### **Novi Food Center Parking Lot Improvements, SITE PLAN NUMBER 09-18**

Novi Food Center Parking Lot Improvements  
SP #09-18

**SUBJECT: Novi Food Center, SP#09-18**  
Traffic Review of Preliminary Site Plan

Novi Food Center  
SP09-18

**REDUCED SITE PLAN**

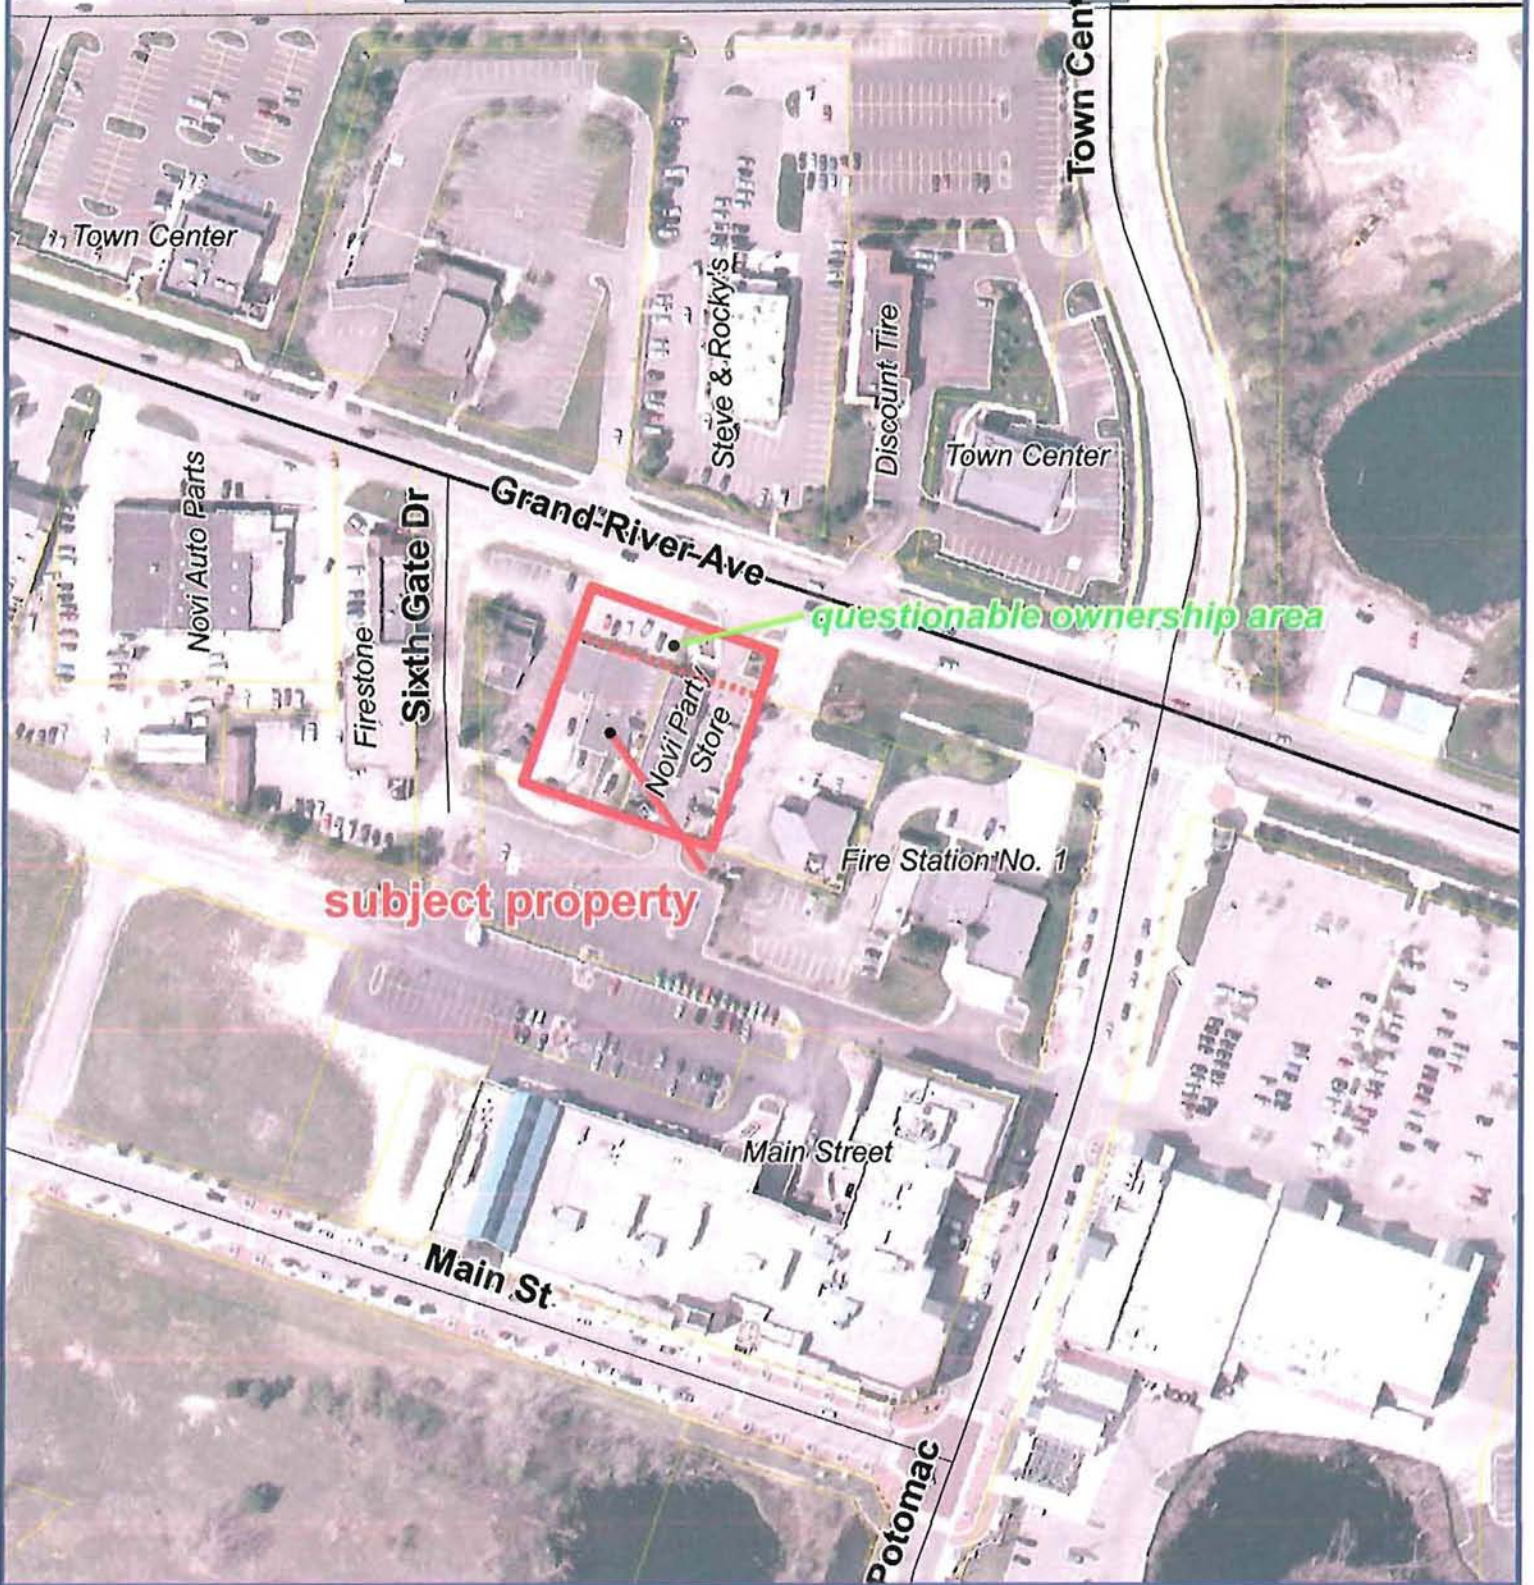
- 1. Schedule of Regulations** The Site Plan demonstrates general compliance with the standards of Section 2400, the Schedule of Regulations, relating to parking setbacks except for adding three additional parking spaces and adjacent access aisle in the apparent City owned Grand River Avenue right-of-way. The existing non-conforming parking and adjacent access aisle is also within the apparent City owned right-of-way. Section 2400 and Section 1602.5 of the Zoning Ordinance requires parking spaces to be set back 20 feet from the right-of-way. The improvements proposed will improve traffic circulation in front of this building, improve the appearance of the front and rear of the site and include an 8 foot pathway adjacent to Grand River Avenue. If City of Novi ownership of the right-of-way is confirmed and retained, the applicant is asked to enter into an agreement with the City Council to maintain the improvements and accept all liabilities. Regardless of the ownership issue, the applicant is asked **obtain a variance from the ZBA to permit zero feet setback for the parking spaces and adjacent access aisle.**

- 3. Parking Lot Aisles** (Sec. 2506) The applicant is proposing a 22 ft. access aisle for the north parking lot and 24 foot is required. Previously the applicant indicated that this would allow the parking to remain on property controlled by the applicant rather than placing part of the aisle in the right-of-way. The current Plan indicates the right-of-way is at the front of the building, thus all of the parking and sidewalks on the north side is located in the right-of-way. **The applicant is asked to increase the width of the access aisle or obtain a variance from the ZBA.**

- b. The proposed driveway would be only about 75 ft west of the party store driveway. **To minimize the operational issues related to such a close same-side driveway spacing, the proposed curb cut should be shifted 5 ft further west.**

4. The proposed new driveway on Grand River appears to be dimensioned as 30 ft wide, face-of-curb to face-of-curb. **This width should be reduced by 1 ft to comply with the City standard that the driveway width be 30 ft back-to-back (see DCS Figure IX.1).**
5. No later than the final site plan, a 24-in STOP (R1-1) sign should be placed at the south edge of the safety path just east of the proposed new Grand River driveway.

8. The proposed aisle width of the north parking lot is shown as 22 ft, or 2 ft less than the standard prescribed by the Zoning Ordinance (Sec 2506.2). **To avoid the need for a variance from the Zoning Board of Appeals (which we would not support), the proposed aisle width should be widened to 24 ft by reducing the internal driveway return radii from 5 ft to 3 ft, thereby narrowing the width of the landscape strip from 8.1 ft to 6.1 ft.**

9. **To improve circulation between the new front parking lot and the party store driveway, the proposed radius at the northeast corner of the party store should be increased to 9 ft from the 5 ft proposed.**

17. Provide a note on the Grading Plan stating the right-of-way pathway will match existing grades at both ends.
18. Realign the 8-foot pathway to angle southwest in order to matchup with the existing ramp east of the Novi Party Store drive approach.

- a. Obtaining a setback variance for three parking spaces and adjacent access aisles from the Zoning Board of Appeals;
- b. Increasing the north driveway width from 22 feet to 24 feet on the Final Site Plan;

In response to your Plan Review Center Report under Comments: Item 1, Schedule of Regulations: The three additional parking spaces are not in the Grand River Ave right-of-way. There was resolution by Road Commission of Oakland County in 1996 to abandon 42 feet of right-of-way, Libre 16568, Page no. 853. Item 2, Parking Spaces: A barrier free ramp from the sidewalk and barrier free sign will be provide per Code. Item 3, Parking Lot Aisles: The proposed 22 ft. access aisle for the north parking lot will be increased to 24 ft. by decreasing the landscaping area by 2 ft. from 8.1 ft. to 6.1 ft. Item 6, Outdoor lighting: We will install one additional decorative fixture west of the entrance drive per your suggestion. A photometric plan will submitted per city requirements. Item 7 Town Center District: We will relocate the pedestrian amenities per your direction.
